Rezoning Transportation Analysis

Petition Number: 2020-099

General Location Identifier: 04705303

General Review Information

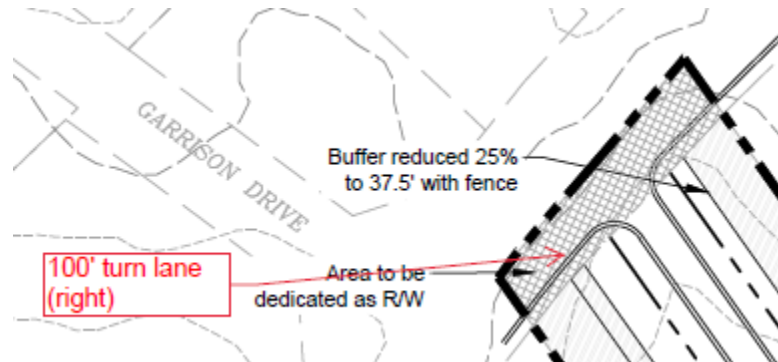
3. ~~**Outstanding** The petitioner should revise the site plan to include the roadway improvements that will be constructed within NCDOT's STIP (#U-2507A). In accordance with Charlotte BIKES, please provide an 8-ft planting strip and a 12-ft multi-use path, if sidewalk is not constructed within the STIP.~~
 - a. ~~**Technical Clarification (site plan dated 09/14/20)** The petitioner should clarify conditional note (Section 3.C.) that 2-ft of additional right-of-way should be dedicated from back of the 12-ft multi-use path. The petitioner should construct a 12-ft multi-use path where the existing sidewalk is removed for the proposed right turn lane. Where the existing sidewalk remains undisturbed along the property frontage, CDOT requests for the existing sidewalk to be widened to 12-ft, in accordance with Charlotte BIKES.~~

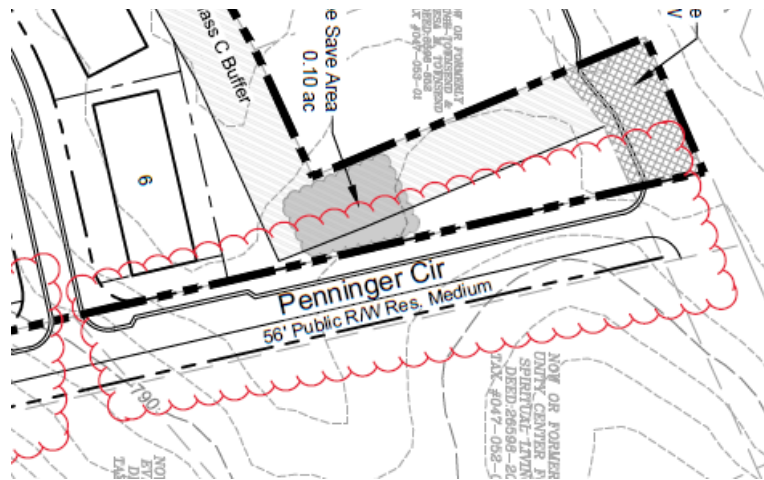
9. ~~The petitioner should remove the proposed access on Mallard Creek Road, as shown below; NCDOT does not support an access at this location of Mallard Creek Road, in reference to the STIP's u-turn bulb-out. Please revise the site plan to provide adequate access for the existing single-family properties, using the proposed USDG Residential Medium/Wide section as proposed below. Please include sidewalk and planting strip on both sides of Penninger Circle.~~

- a. ~~**Technical Clarification (site plan dated 09/14/20)** The petitioner should clarify the site plan to show and call-out the existing Penninger Circle private drive that ties into existing Mallard Creek Road. CDOT requests the petitioner to clarify that the existing Penninger Circle road improvements will be constructed in accordance with *CLDSMU-02 - Local Residential Medium Section* cross section design standards, on both sides of the existing Penninger Circle road centerline.~~
